DESIGN REVIEW RECOMMENDATION  
MAY 6, 2024 MEETING

SDCI #3040275-LU  
6102 14th Ave NW  
Seattle, WA 98107

Applicant:  
Cone Architecture  
1319 N 49th Street  
Seattle, WA 98103  
Contact: Emily Terzic

REC MASSING - INTEGRATED DECK AND ENTRY DESIGN

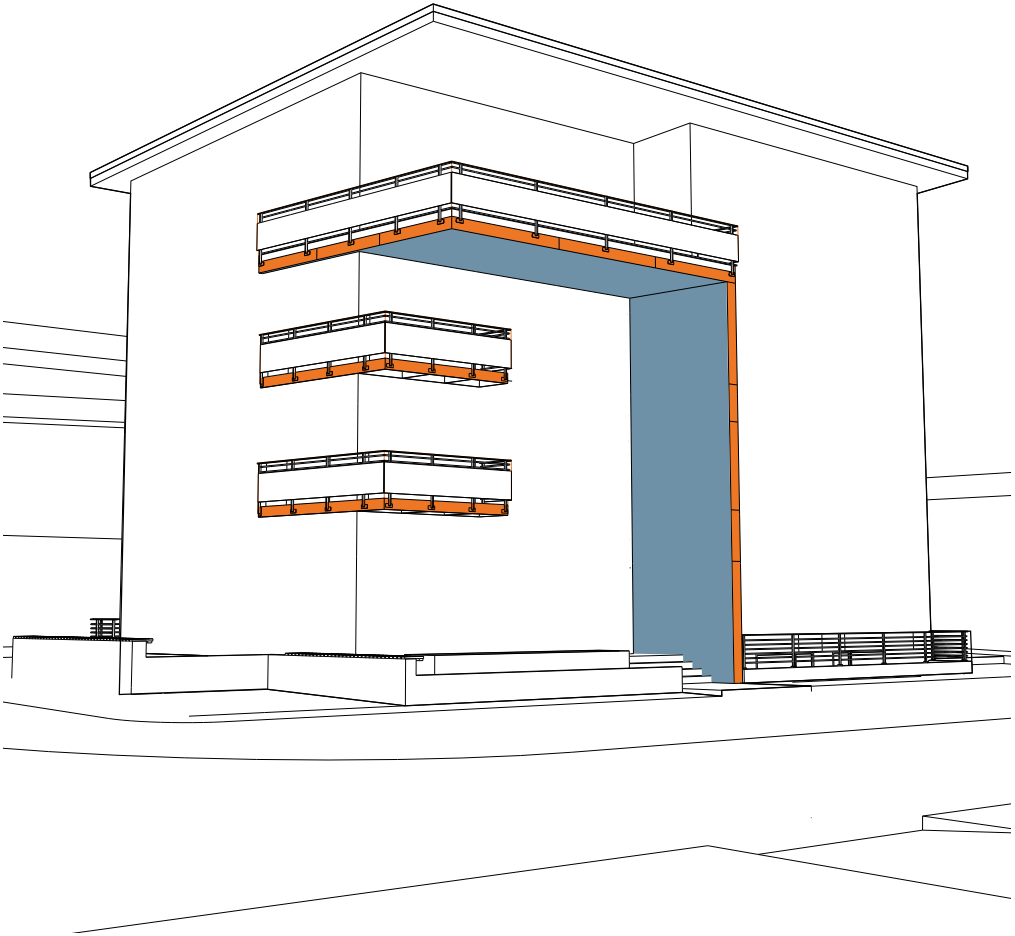
*The Board urged additional integration of the third-floor balcony on the south façade into the design concept of Option 3, stating that its current expression appears to be an awkward attachment to the simple massing form. The Board encouraged the development of a consistent strategy for integrating secondary architectural elements, such as balconies, into the design concept (DC2-B-1. Façade Composition, DC2-C. Secondary Architectural Features).*

The proposed fourth floor balcony on the south façade has been further integrated into the overall design concept through the addition of complimentary decks on level 2 and 3, creating a stacked condition that fits into the existing context of the neighborhood. Level two and three decks are pulled back to highlight the three story residential entry, with the fourth level deck's cedar soffit wrapping down for a warm, pedestrian scaled material. This typology of repeating decks is present in many neighboring apartment buildings, which can be further seen through the diagram on page 16.

Secondary architectural features including numerous juliet balconies bring the language of the metal railings of level 2, 3 and 4 decks to the west and south facade. The juliet railing placement corresponds with sliding door operability emphasizing the playful stacking of glazing. Juliet balconies provide access to outdoor space for all units while the level one patio allows for larger outdoor gatherings.

VIEW FROM NW 61ST ST OF ZONE TRANSITION

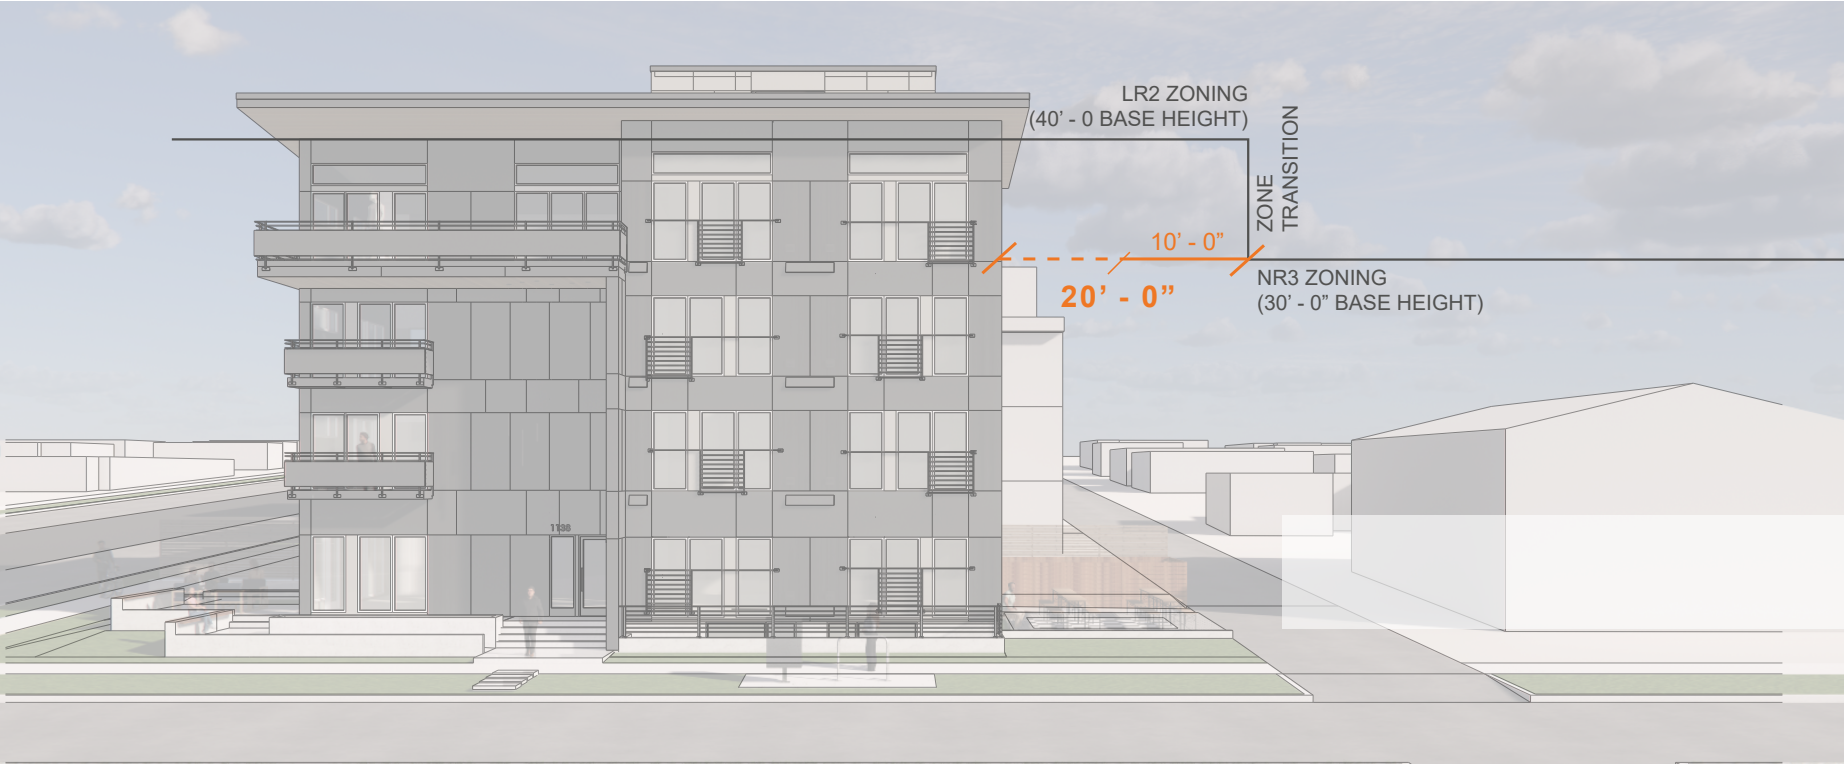
The Board requested a site section drawing and a window privacy diagram at the Recommendation phase of review to show how the proposed building mass will relate to adjacent development in the Neighborhood Residential 3 zone to the east of the site and maintain privacy to adjacent residents (CS2-D-3. Zone Transitions, CS2-D-5 Respect for Adjacent Sites, PL3-B-1. Security and Privacy).

Please reference the provided diagrams to see the minimal overlap in glazing between the proposed design and adjacent buildings.

The site elevation along NW 61st St shows the additional 10'-0" provided at the zone transition to allow for greater separation between the triplex and the proposed design. The eastern amenity space acts as a buffer at this transition while providing double the required setback.

### SOUTH WINDOW WELL ENLARGED SECTION

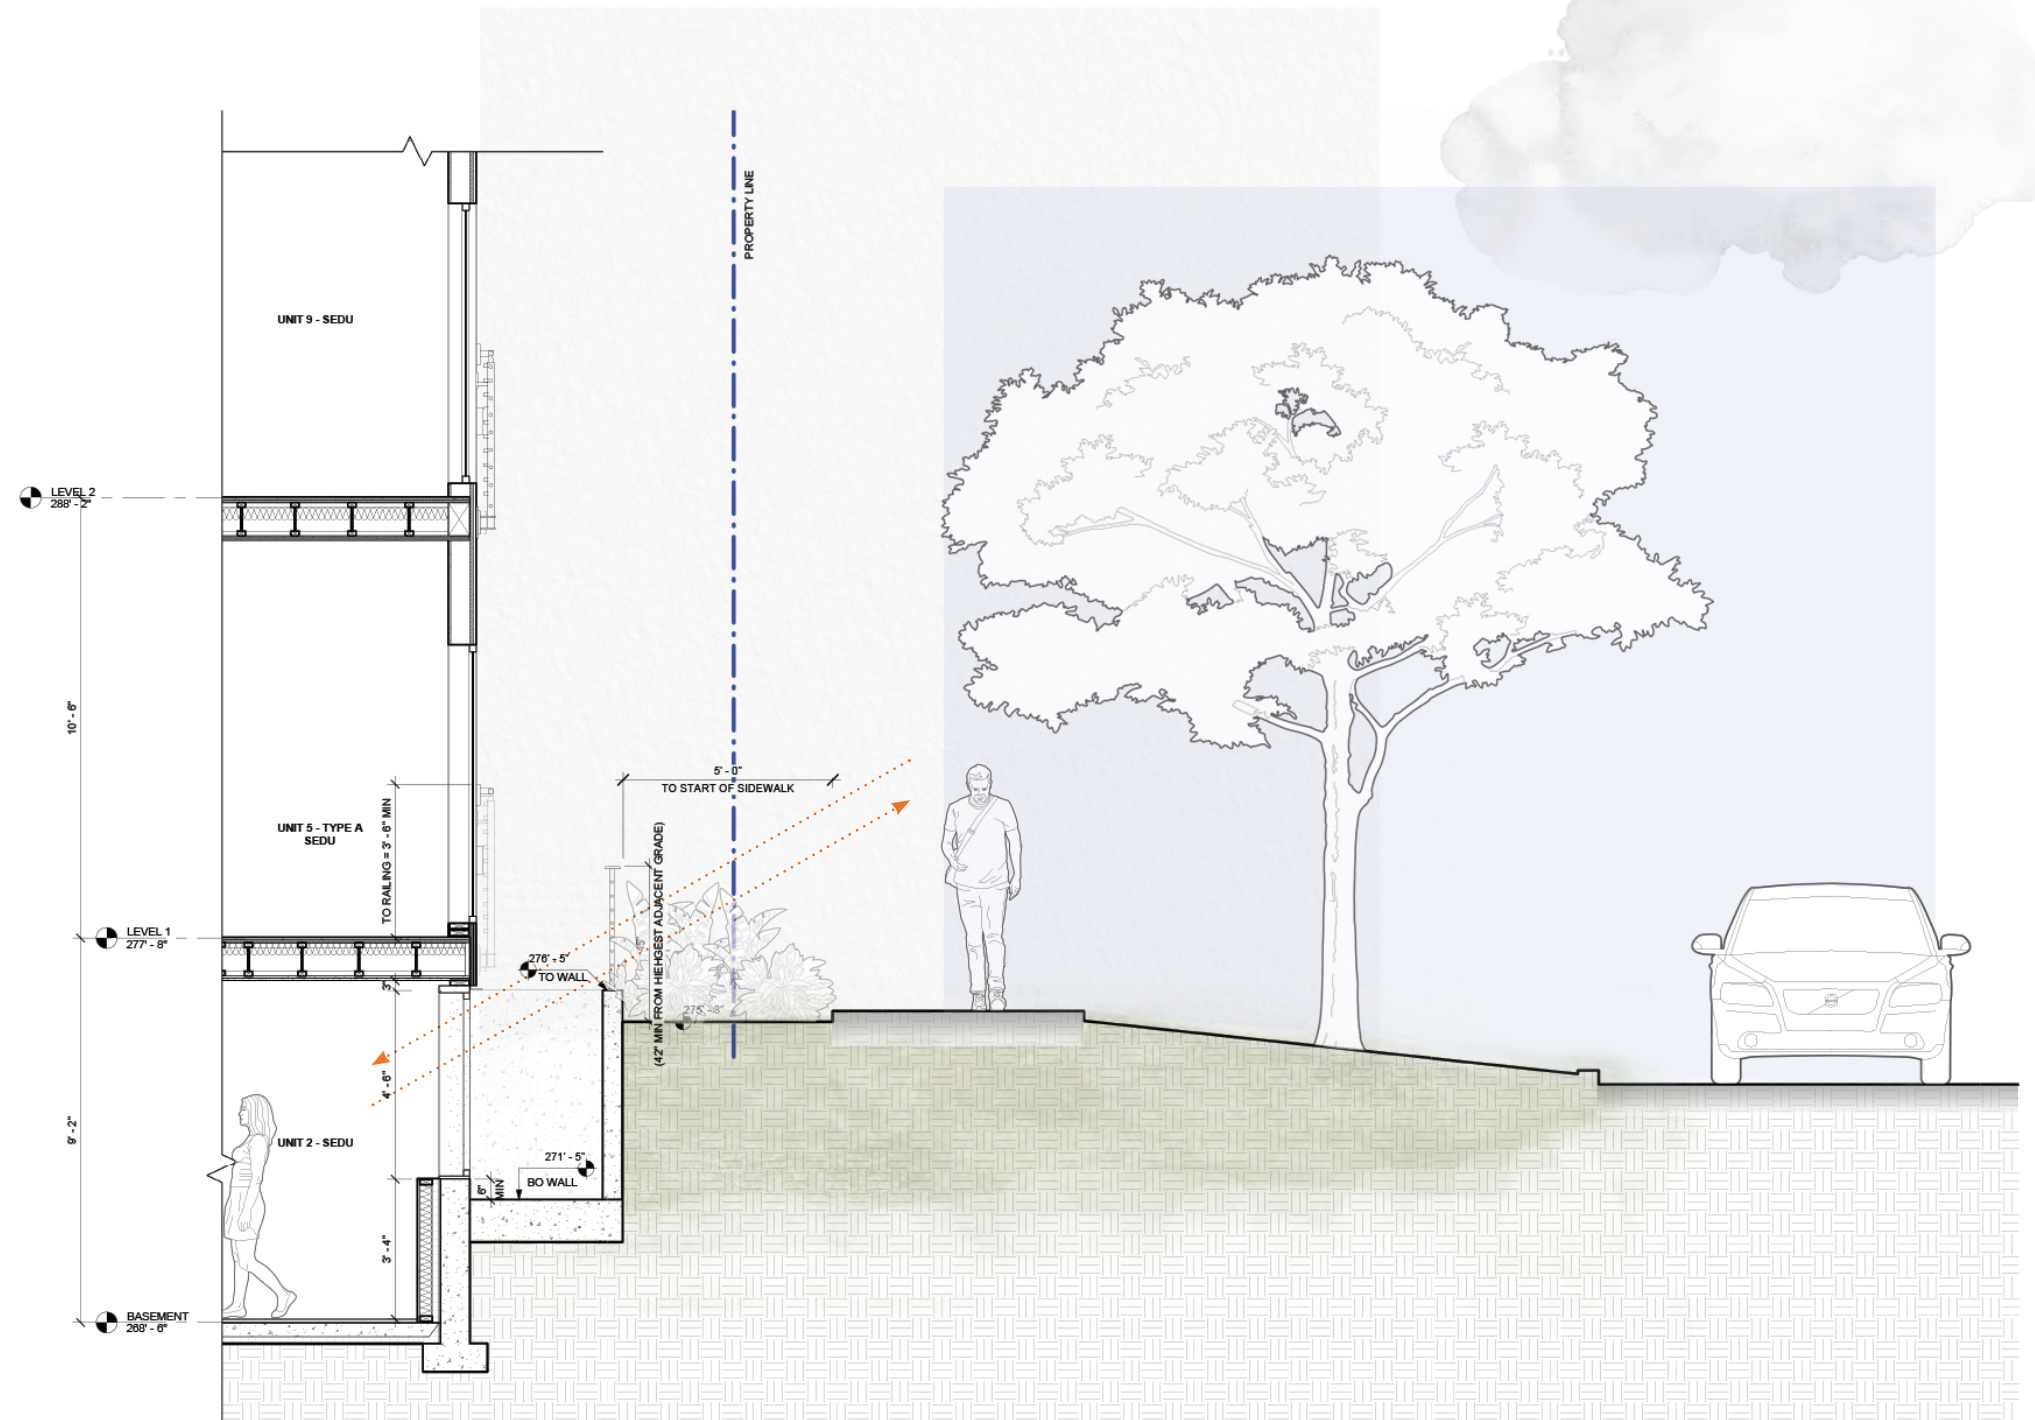
*The Board requested additional information at the Recommendation phase of review to demonstrate the livability of basement-level units related to the availability of light. Information provided at Recommendation should include section drawings of the window wells (CS1-B-2. Daylight and Shading, PL3-B-2. Ground-level Residential)*

Glazing has been maximized at the north and south lower level units, as seen in the two enlarged sections, to optimize livability and access to light and air.

Added details are included within the sections showing requirements for fall protection. To minimize the impact of the railings and reinforce privacy, landscaping is placed strategically.

Since EDG, the previously north window well has shifted to the west, encouraging more daylight opportunities for this lower level unit.

REC PROPOSED DESIGN SITE PLAN

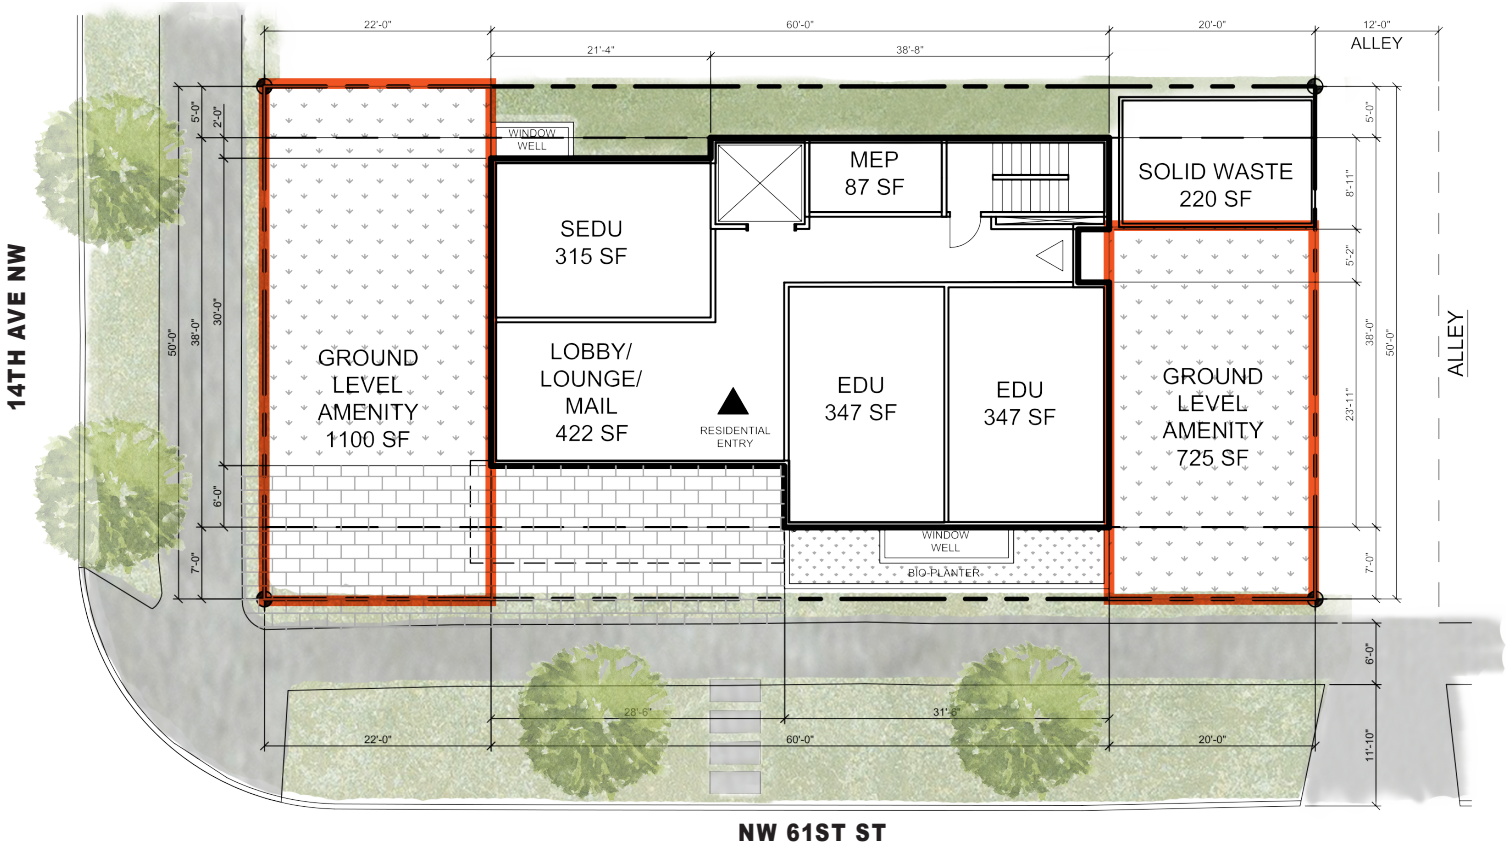
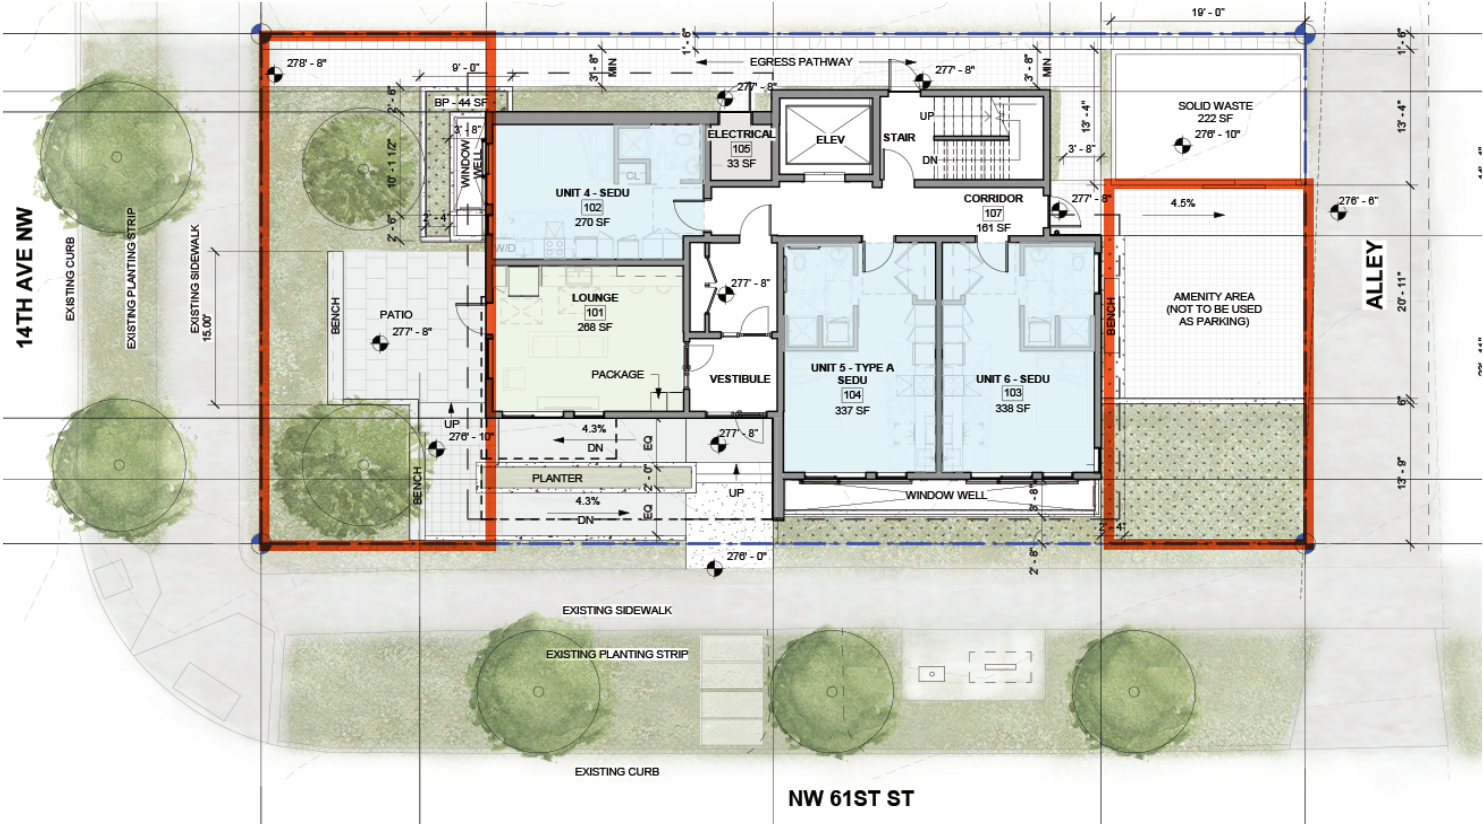
The Board generally supported layout of Option 3 with separate amenity spaces on the east and west sides of the site, stating that the western space relates well to Gemenskap Park, while the rear setback provided by the eastern space allows for an appropriate zone transition to the east.

The size of the proposed open spaces has been maintained from Option 3 at EDG. See the adjacent diagrams outlining the amenity spaces proposed at the EDG meeting for the preferred massing along with the proposed design. In addition, these amenity spaces have been carefully composed with a variety of landscaped and hardscaped areas, built-in seating, and integrated lighting to promote opportunities for people to gather and linger.
